Addendum 02

PROJECT: Cedar Cliff Schools Connector Addition and Renovation
194 Walnut St.
Cedarville, Ohio 45314

PROJECT #: 25056.00

BORING LOG

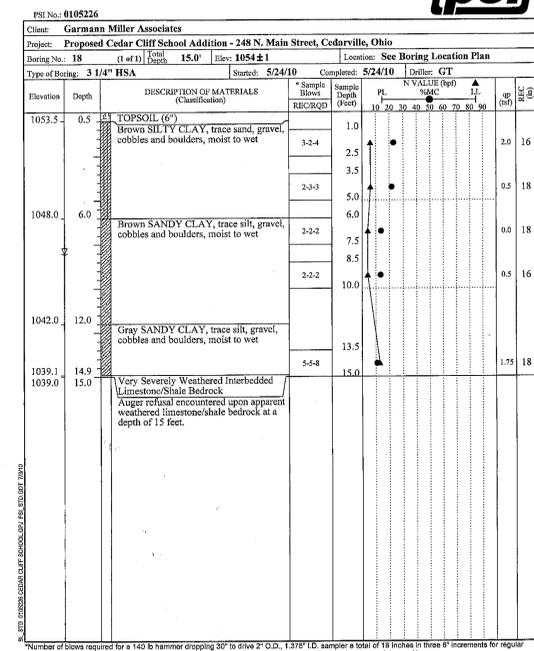
1. Drawing Sheet S0.1 – Structural Notes
 - a. Structural notes on S0.1 include deep foundation system in the delegated design system. Helical piles are shown in Section C/S2.0 but other deep foundation systems, such as rammed aggregate piers or drilled caissons are also acceptable upon review. The design intent is for the column reactions to bear on rock 15' below the surface in the most economical method. Boring log 18 from 2010 is included on sheet S0.1 for reference.

BORING LOG 18 FROM 2010 IS INCLUDED ON SHEET S0.1 FOR REFERENCE.

DIVISION 3 - FOUNDATIONS AND CONCRETE: 1. MAXIMUM ALLOWABLE BEARING PRESSURE = 100,000 PSF AT SOUND INTACT LIMESTONE BEDROCK, REF. GEOTECHNICAL REPORT DATED JULY 12, 2010 BY PROFESSIONAL SERVICE INDUSTRIES REPORT NO. 016526. DEEP FOUNDATIONS SHALL BEAR ON BEDROCK 15 FT BELOW GRADE. SEE BORING LOG 18.

STRUCTURAL COMPONENTS, ASSEMBLIES, AND SYSTEM DELEGATED TO THE CONTRACTOR INCLUDE THE FOLLOWING: 1. COLD-FORMED STEEL FRAMING; 2. HELICAL PILES OR OTHER DEEP FOUNDATION SYSTEM; 3. HELICAL PILES ARE SHOWN IN SECTION C/S2.0 BUT OTHER DEEP FOUNDATION SYSTEMS, SUCH AS RAMMED AGGREGATE PIERS OR DRILLED CAISSONS ARE ALSO ACCEPTABLE UPON REVIEW. THE DESIGN INTENT IS FOR THE COLUMN REACTION TO BEAR ON ROCK 15' BELOW THE SURFACE IN THE MOST ECONOMICAL METHOD.
